TVA-SQN-TS-03-12

**SEQUOYAH NUCLEAR PLANT (SQN) UNITS 1 AND 2 TECHNICAL
SPECIFICATIONS (TS) CHANGE 03-12, "APPLICATION FOR TECHNICAL
SPECIFICATION IMPROVEMENT TO EXTEND THE COMPLETION TIME FOR
ACTION A OF TECHNICAL SPECIFICATION 3/4.5.1, 'ACCUMULATORS,'
USING THE CONSOLIDATED LINE ITEM IMPROVEMENT PROCESS (CLIIP)"**

TENNESSEE VALLEY AUTHORITY (TVA) SEQUOYAH NUCLEAR PLANT (SQN) UNITS 1 AND 2

Proposed Technical Specification Changes (mark-up)

3/4.5.1 ACCUMULATORS

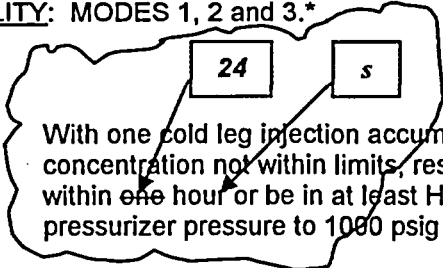
- 
- a. With one cold leg injection accumulator inoperable, except as a result of boron concentration not within limits, restore the inoperable accumulator to OPERABLE status within one hour or be in at least HOT STANDBY within the next 6 hours and reduce pressurizer pressure to 1000 psig or less within the following 6 hours.
 - b. With one cold leg injection accumulator inoperable due to the boron concentration not within limits, restore boron concentration to within limits within 72 hours or be in at least HOT STANDBY within the next 6 hours and reduce pressurizer pressure to 1000 psig or less within the following 6 hours.

The proposed amendment would extend the completion time from 1 hour to 24 hours for "Action a" of TS 3/4.5.1, "Accumulators." The change is consistent with Nuclear Regulatory Commission approved Industry/Technical Specification Task Force (TSTF) Standard Technical Specification Change Traveler, TSTF-370, "Risk Informed Evaluation of an Extension to Accumulator Completion Times for Westinghouse Plants." The availability of this TS improvement was announced in the *Federal Register* on March 12, 2003, as part of the CLIIP.

3/4.5.1 ACCUMULATORS

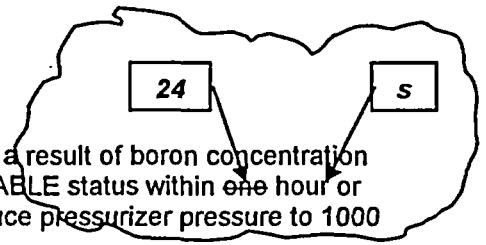
- a. With one cold leg injection accumulator inoperable, except as a result of boron concentration not within limits, restore the inoperable accumulator to OPERABLE status within one hour or be in at least HOT STANDBY within the next 6 hours and reduce pressurizer pressure to 1000 psig or less within the following 6 hours.
- b. With one cold leg injection accumulator inoperable due to the boron concentration not within limits, restore boron concentration to within limits within 72 hours or be in at least HOT STANDBY within the next 6 hours and reduce pressurizer pressure to 1000 psig or less within the following 6 hours.
